DART AEROSPACE LTD	Work Order: 109060
Description: Crosstube Assembly (412 Low Aft)	Part Number: D412-664-249
Inspection Dwg: D412-664-249 Rev: B	Page 1 of 2

DRAWING NO. D412-664-249	TITLE CROSSTUBE ASS'Y (412 LOW AFT)	REV. B	DART AEROSPACE LTD ENGINEERING ORDER	D.E.O. NO. D412-664-249-B-1	SHEET NO. SHEET 1 OF 2	SCALE NTS
DRAWN <i>Q</i>	CHECKED <i>Sc</i>	MFG. APPR. <i>E</i>	APPROVED <i>MD</i>	DE APPR. <i>MD</i>		
DATE 11.05.25	DATE 11.05.31	DATE 11.05.31	DATE 11/05/31	DATE 11.05.31

DRAWING NO. D412-664-249	TITLE CROSSTUBE ASS'Y (412 LOW AFT)	REV. B	DART AEROSPACE LTD ENGINEERING ORDER		D.E.O. NO. D412-664-249-B-2	SHEET NO. SHEET 1 OF 1	SCALE NTS
DRAWN 9	CHECKED AS	MFG. APPR. E	APPROVED WAP		DE APPR. H		
DATE 11.09.07	DATE 11.09.19	DATE 11.09.19	DATE 11.09.19		DATE 11.09.19

DRAWING NO. D412-664-249	TITLE CROSSTUBE (412 LOW AFT)	REV. B	DART AEROSPACE LTD ENGINEERING ORDER		D.E.O. NO. D412-664-249-B-3	SHEET NO. SHEET 1 OF 3	SCALE NTS
DRAWN <i>q</i>	CHECKED <i>h</i>	MFG. APPR. <i>h</i>	APPROVED <i>h</i>	DE APPR. <i>h</i>			
DATE 12.08.21	DATE 12.08.30	DATE 12.08.30	DATE 12.08.30	DATE 12.08.30	DATE 12.08.30

D412-664-249
ASSEMBLY DETAIL

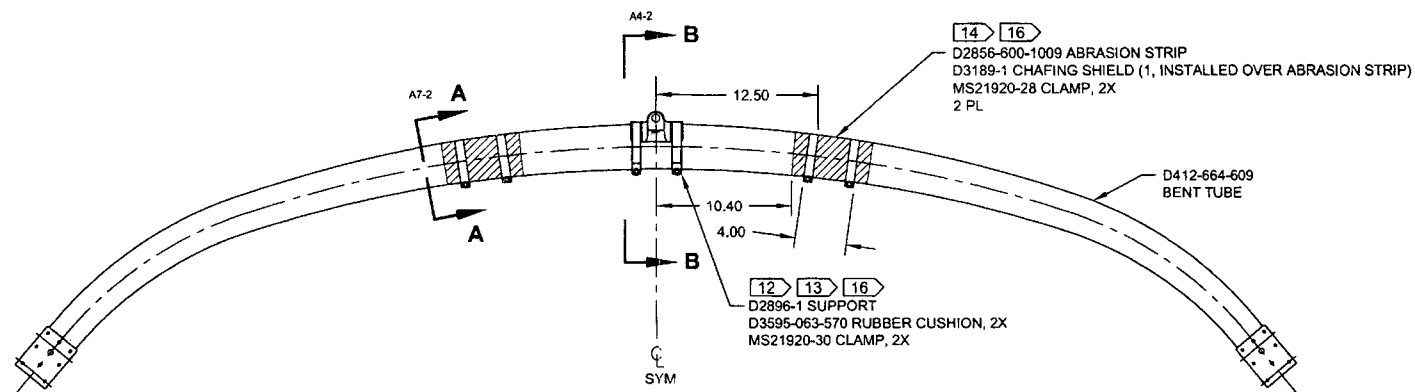
PURPOSE:

REMOVED ABRASION STRIP IN FAVOR OF A THIN LAYER OF PROSEAL 890.

IS:

D3189-1 CHAFING SHIELD (1, INSTALLED OVER PROSEAL 890)
MS21920-28 CLAMP, 2X
2 PL

WAS:

D2856-600-1009 ABRASION STRIP
D3189-1 CHAFING SHIELD (1, INSTALLED OVER ABRASION STRIP)
MS21920-28 CLAMP, 2X
2 PL

SECTION A-A
CHAFING SHIELD DETAIL
VIEW ROTATED, NOT TO SCALE

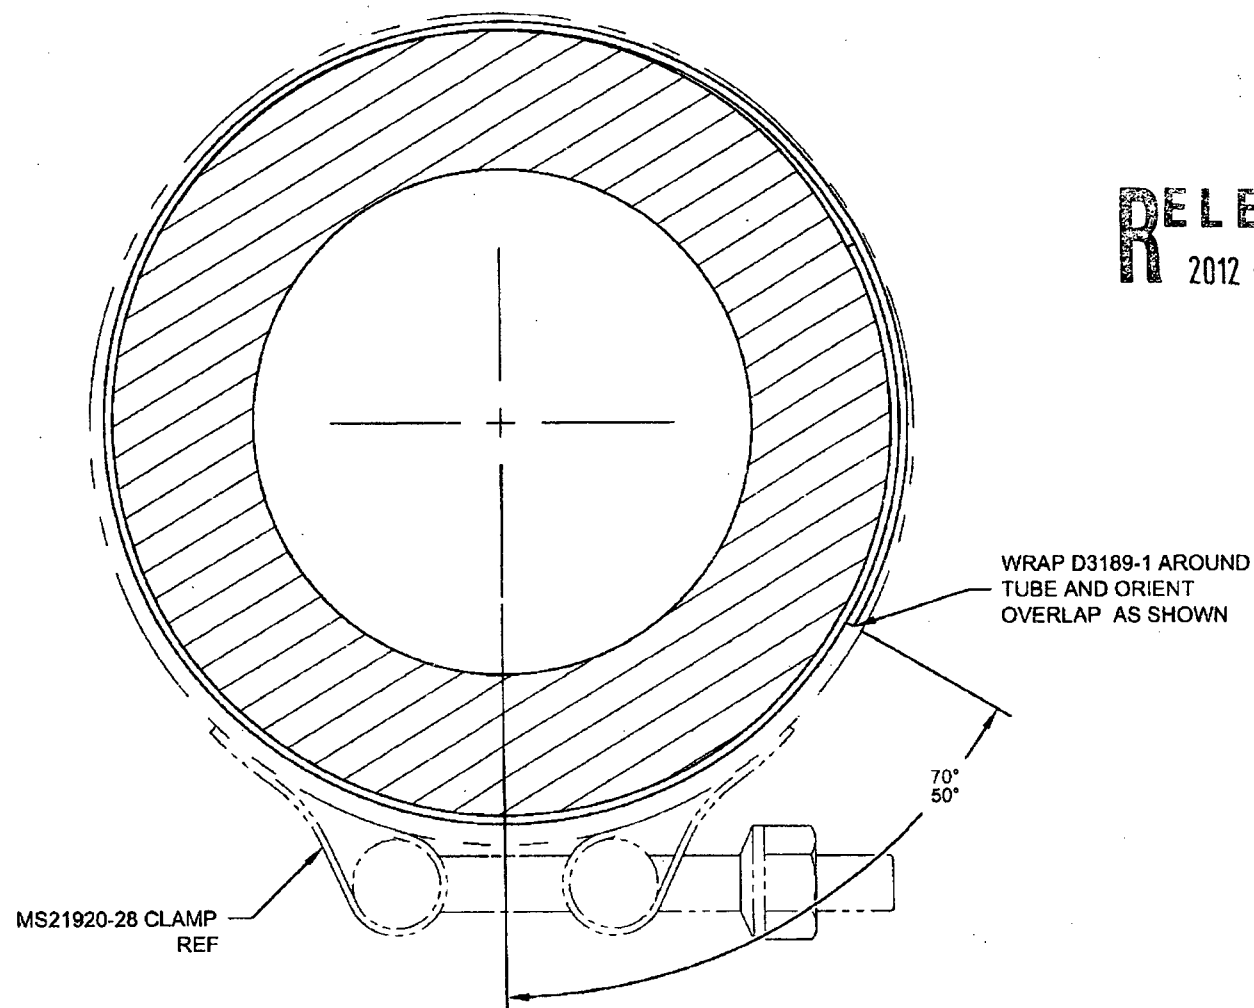
PURPOSE:

REMOVED ABRASION STRIP IN FAVOR OF A THIN LAYER OF PROSEAL 890. UPDATE INSTALLATION OF CHAFING SHIELDS AND REDUCE TORQUE TO 40-50 IN-LBS. THIS ENGINEERING ORDER SUPERCEDES DEO D412-664-249-B-1

NOTE 14 AND 16 ON SHEET 1 IS AMENDED AS FOLLOWS:

- 14) APPLY A THIN COAT OF PROSEAL 890 ON INSIDE CONCAVE SURFACE OF D3189-1 CHAFING SHIELD AND LET CURE PER MANUFACTURER'S INSTRUCTIONS. INSTALL PROSEALED D3189-1 CHAFING SHIELD ONTO CROSSTUBE BY APPLYING A THIN COAT OF PROSEAL 890 ONTO CROSSTUBE. BE SURE TO ELIMINATE ANY AIR GAPS.
- 16) TORQUE CLAMPS ON D2896-1 SUPPORT 80 TO 100 IN-LB. **TORQUE CLAMPS ON D3189-1 CHAFING SHIELD 40 TO 50 IN-LB.** ENSURE AT LEAST 1.5 THREADS SHOWING IN SAFETY AND THAT NUT HAS NOT BOTTOMED-OUT AFTER TORQUING.

- 14) INSTALL D2856-600-1009 ABRASION STRIPS WITH A 0.13 REF GAP ON BOTTOM SIDE OF CROSSTUBE PER QSI 035.
- 16) TORQUE CLAMPS 80 TO 100 IN-LB. ENSURE AT LEAST 1.5 THREADS SHOWING IN SAFETY AND THAT NUT HAS NOT BOTTOMED-OUT AFTER TORQUING.
